Access Compliance Report

Public Rights-of-Way

Intersection ID: 54460	Main Street: STEELE_MEADOW_RD	Cross Street: FLINT_HILL_DR	Location: NW
ADA ID: 8F38C687081A	Ramp Type: BlendTrans1	Initial Pass/Fail: Fail	Overall Compliance: No
		Severity Score: 8.75

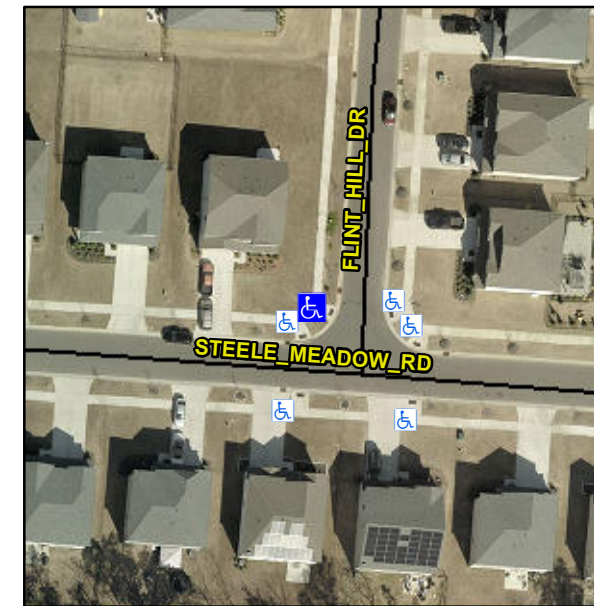
Not Found, R304.5.1

Remove & Replace Curb Ramp With Two New Directional Ramps or Equivalent.
